Access Compliance Report Public Rights-of-Way (Curb Ramps)

Main Street: FAIRHAVEN_AVE Cross Street: FLINT_DR Location: S

ADA ID: RPAT211021102456 Ramp Type: Type 1 - Perpendicular Diagonal Initial Pass/Fail: Fail Overall Compliance: No Severity Score: 30

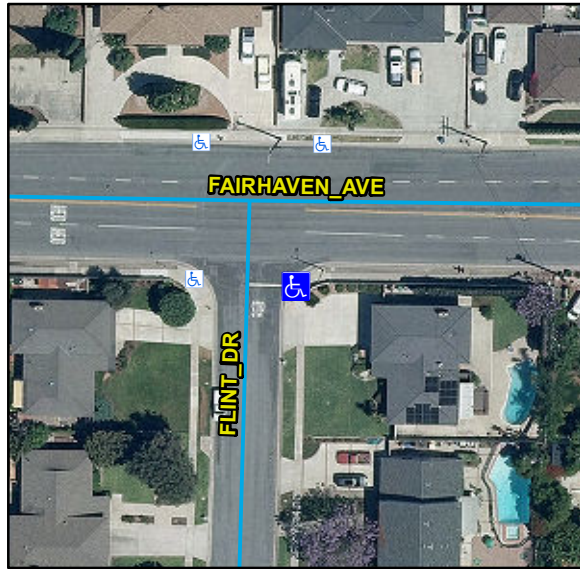
Compliance	Description	Data	Compliance	Description	Data
N/A	Ramp Length (in)	91	N/A	Flare Type LT	
Yes	Ramp Width (in)	52			N/A
No	Ramp Run Slope (%)	9.6	N/A	Flare Slope LT (%)	N/A
No	Ramp Cross Slope (%)	6.7	N/A	Flare Traversable LT	N/A
N/A	Landing Present	N/A	N/A	Flare Type RT	
N/A	Landing Length (in)	N/A			N/A
N/A	Landing Width (in)	N/A	N/A	Flare Slope RT (%)	N/A
N/A	Landing Run Slope (%)	N/A	N/A	Flare Traversable RT	N/A
N/A	Landing Cross Slope (%)	N/A	N/A	DWS Provided	N/A
N/A	Landing Movement Obstructed?	N/A	N/A	DWS Contrast	N/A
	Landing Movement Type	N/A	N/A	DWS Length (in)	N/A
N/A	Landing Shared	N/A	N/A	DWS Full Width	N/A
N/A	Clear Space	Yes	N/A	DWS Offset Left (in)	N/A
N/A	Clear Space To Crosswalk (in)	N/A	N/A	DWS Offset Right (in)	N/A
N/A	Marked Crosswalk 1	No	N/A	Marked Crosswalk 2	No
	Crossing 1 Direction	NE		Crossing 2 Direction	NW
	Marked Crosswalk 1 Width (in)	N/A		Marked Crosswalk 2 Width (in)	N/A

N/A	Ramp Inside Crosswalk 1	N/A	Yes	Ramp Inside Crosswalk 2	N/A
	Crossing 1 Slope (%)	4.6		Crossing 2 Slope (%)	0.1
	Crossing 1 Cross Slope (%)	2.4		Crossing 2 Cross Slope (%)	4.9
N/A	Gutter Ponding	N/A	No	Curb Slope	11.4
Yes	Gutter Lip Height (in)	0		Road Run Slope (%)	6.6
N/A	Gutter Run Slope (%)	N/A		Road Cross Slope (%)	3.7
N/A	Gutter Cross Slope (%)	N/A			
Yes	Overall Surface Condition: Acceptable		Yes	Perp Joint Present	Yes
	Cross Gutter Present?	No		Spandrel Present?	No
	Replace Cross Gutter?	N/A		Replace Spandrel?	N/A

Remove & Replace Curb Ramp With Two New Directional Ramps or Equivalent.

R304.2.2, R304.5.3, STD 1115
